Engineering Referral Response

Application Number:	DA2023/1933
Proposed Development:	Alterations and additions to a dwelling house including a double carport
Date:	21/06/2024
To:	Reeve Cocks
Land to be developed (Address):	Lot C DP 162702 , 31 Montauban Avenue SEAFORTH NSW 2092

DRIVEWAY SECTION EAST EDGE

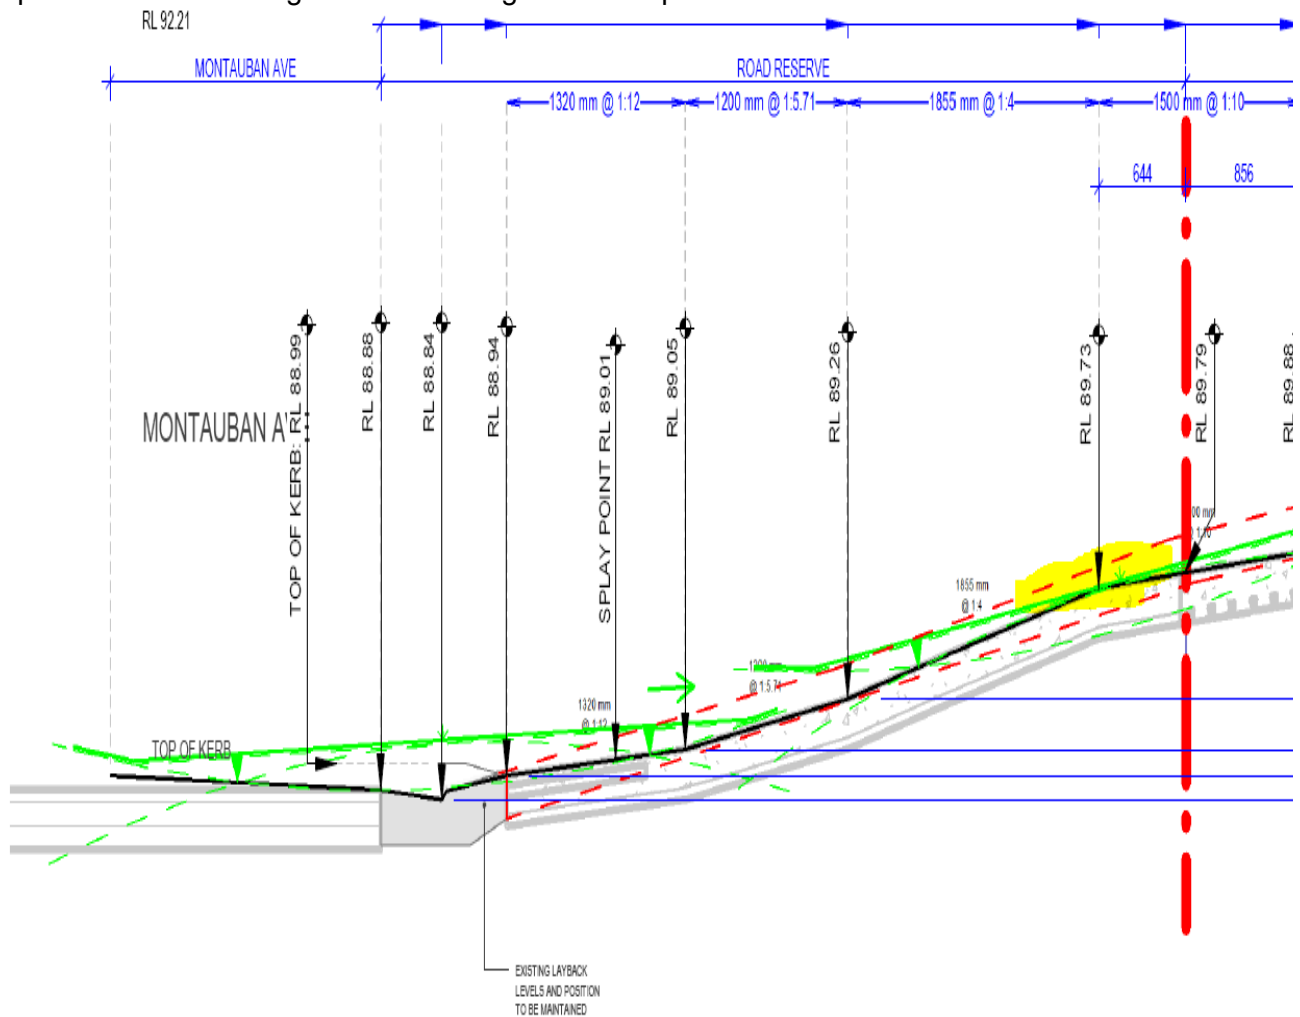
Access

The submitted longsections are not satisfactory. Based on the sections provided vehicles appear to scrape on the eastern edge of the crossing. A profile in accordance with Council's standard drawing Maximum High is recommended.

Access

The submitted longsections are not satisfactory. Based on the sections provided vehicles appear to scrape on the eastern edge of the crossing. Refer snapshot below:

A profile in accordance with Council's standard drawing Maximum High is recommended. The applicant shall provide engineering longsections at both edges of the proposed vehicle crossing including chainage, existing and proposed levels and grades.
